Access Compliance Report

Public Rights-of-Way

(Island Curb Cuts)

Intersection ID: 27325	Main Street: TILLEY MORRIS RD	Cross Street: N/A	Location: W
ADA ID: 47BD4E9D17C2	Curb Cut Type: IslandRefuge2	Initial Pass/Fail: Fail	Overall Compliance: No
Codes/Mitigation Info/Possible Solution		Field Measurements/Component Compliance	
Severity Score: 1.25

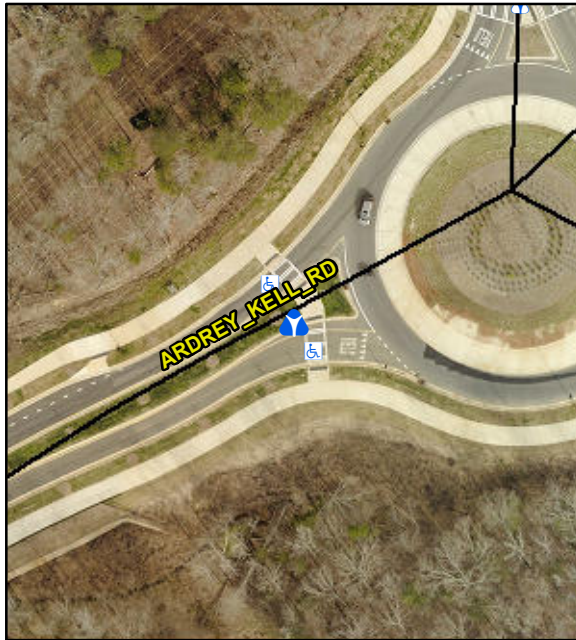
Compliance	Description	Data	Compliance	Description	Data
Yes	Refuge 1 Length (In)	108.0	N/A	Gutter 1 Ponding?	N/A
Yes	Refuge 1 Width (In)	120.0	N/A	Gutter 1 Lip Ht (In)	N/A
Yes	Refuge 1 Slope (%)	3.6	N/A	Gutter 1 Slope (%)	N/A
Yes	Refuge 1 X Slope (%)	3.3	N/A	Gutter 1 X Slope (%)	N/A
N/A	Painted X Walk1?	Yes	N/A	DWS 1 Provided?	N/A
N/A	X Walk 1 Direction	To S	N/A	DWS 1 Contrast?	N/A
N/A	X Walk 1 Width (In)	112.0	N/A	DWS 1 Length (In)	N/A
N/A	Road 1 Slope (%)	2.8	N/A	DWS 1 Full Width?	N/A
N/A	Road 1 X Slope (%)	1.8	N/A	DWS 1 Offset (In)	N/A
Yes	Refuge 2 Length (In)	112.0	N/A	Gutter 2 Ponding?	N/A
Yes	Refuge 2 Width (In)	120.0	N/A	Gutter 2 Lip Ht (In)	N/A
Yes	Refuge 2 Slope (%)	1.5	N/A	Gutter 2 Slope (%)	N/A
Yes	Refuge 2 X Slope (%)	3.2	N/A	Gutter 2 X Slope (%)	N/A
N/A	Painted X Walk2?	Yes	N/A	DWS 2 Provided?	N/A
N/A	X Walk 2 Direction	To N	N/A	DWS 2 Contrast?	N/A
N/A	X Walk 2 Width (In)	112.0	N/A	DWS 2 Length (In)	N/A

N/A	Road 2 Slope (%)	3.2	N/A	DWS 2 Full Width?	N/A
N/A	Road 2 X Slope (%)	0.3	N/A	DWS 2 Offset (In)	N/A
N/A	Refuge 3 Length (in)	N/A	N/A	Gutter 3 Ponding?	N/A
N/A	Refuge 3 Width (in)	N/A	N/A	Gutter 3 Lip Ht (in)	N/A
N/A	Refuge 3 Slope (%)	N/A	N/A	Gutter 3 Slope (%)	N/A
N/A	Refuge 3 XSlope (%)	N/A	N/A	Gutter 3 XSlope (%)	N/A
N/A	Painted X Walk3?	N/A	N/A	DWS 3 Provided?	N/A
N/A	X Walk 3 Direction	N/A	N/A	DWS 3 Contrast?	N/A
N/A	X Walk 3 Width (in)	N/A	N/A	DWS 3 Length (in)	N/A
N/A	Road 3 Slope (%)	N/A	N/A	DWS 3 Full Width?	N/A
N/A	Road 3 XSlope (%)	N/A	N/A	DWS 3 Offset (in)	N/A
Yes	Any Obstructions?	N/A	N/A	Storm Grate/Utility Hazard?	N/A
N/A	Obstruction Type		N/A	Storm Grate/Utility Type	
		N/A			N/A
N/A	Surface Condition	Good

Remove & Replace Entire Refuge.
